SUBJECT: Forwards response to 880223 request for addl info re Generic Ltr 86-06, "Reactor Coolant Pump Trip Criteria." CEN-268 revised to delete any ref to use of containment radiation alarms as possible criteria for tripping second two pumps.

Re: St. Lucie Units 1 and 2
Docket Nos. 50-335 and 50-389
Generic Letter 86-06
Reactor Coolant Pump Trip Criteria

ATTACHMENT 1
FPL RESPONSE TO ADDITIONAL QUESTIONS
RE GENERIC LETTER 86-06
IMPLEMENTATION REQUIREMENTS

0.1 FT² HOT LEG BREAK
 STEAM BYPASS SYSTEM OPERATIONAL
 RCS (PRESSURIZER) PRESSURE
 AND
 SG PRESSURE

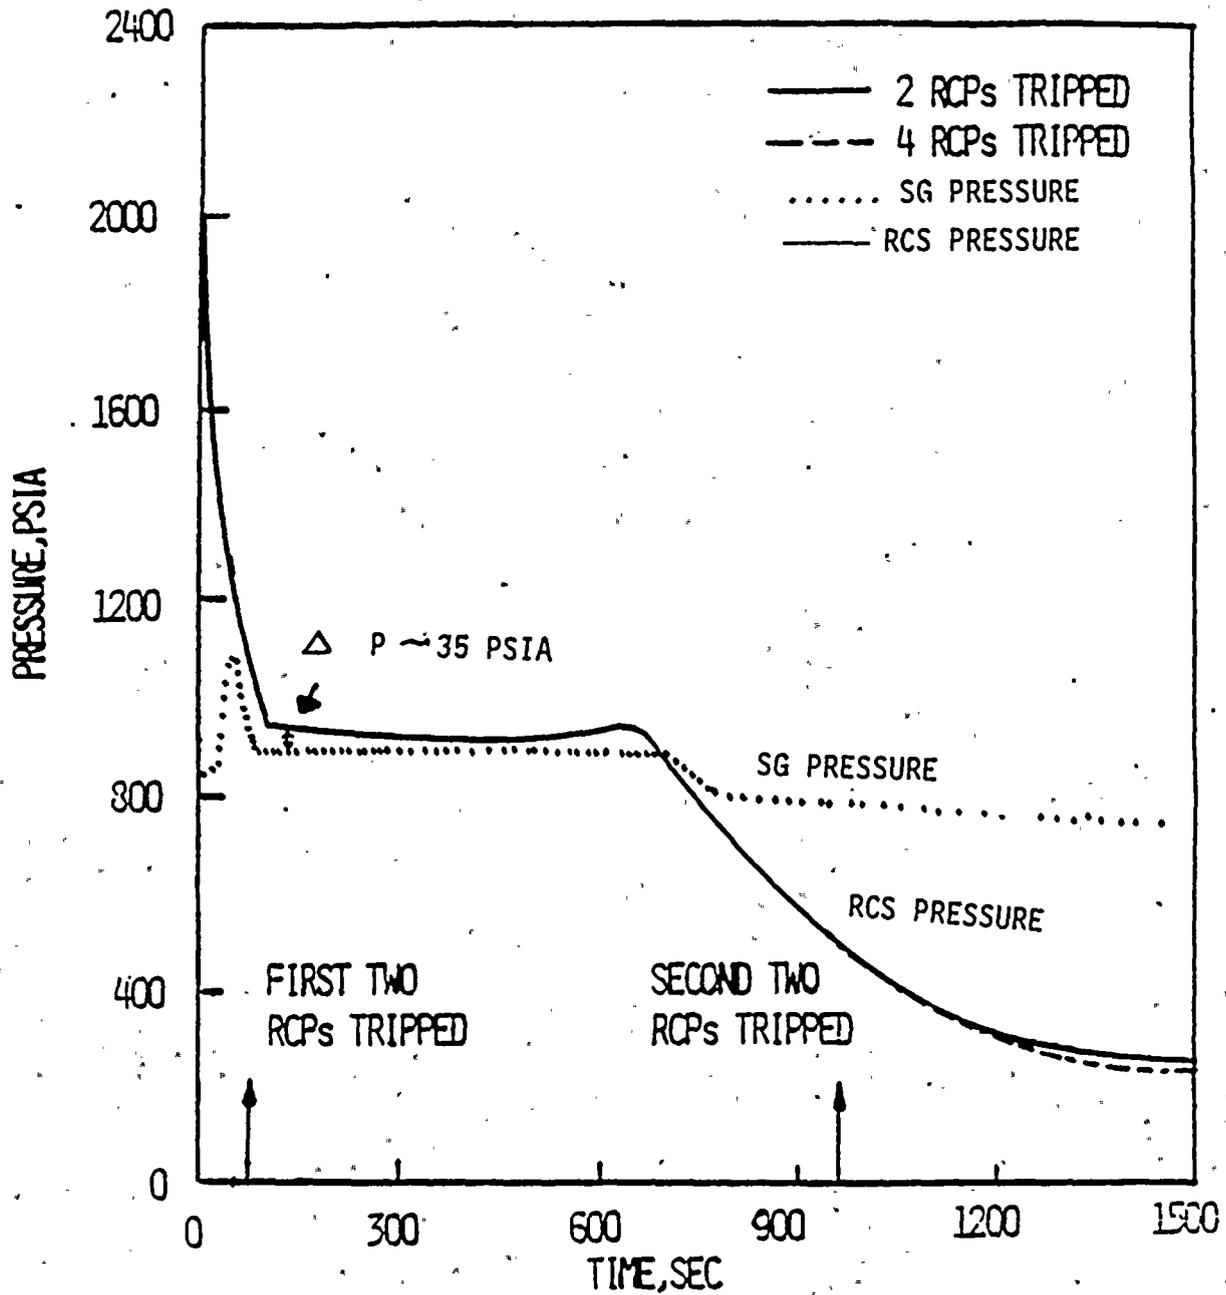
Noting from CEN-268, Supplement 1-P, that the RCS pressure plateaus are established at about the same time as P_{sec} stabilizes, it follows that a realistic calculation of pressure plateaus will use either 900 psia or 1000 psia depending upon what is controlling P_{sec} . The graph compiled from CEN-268, Supplement 1-P, data shows the evolution of the pressure plateau in terms of the secondary pressure at 900 psia. T_{sec} data corresponding to the above secondary pressures are:

In summary, the realistic pressure plateaus are about 35 to 40 psia above the corresponding secondary pressure. These values have been rounded up to 50 psia for use in this analysis.
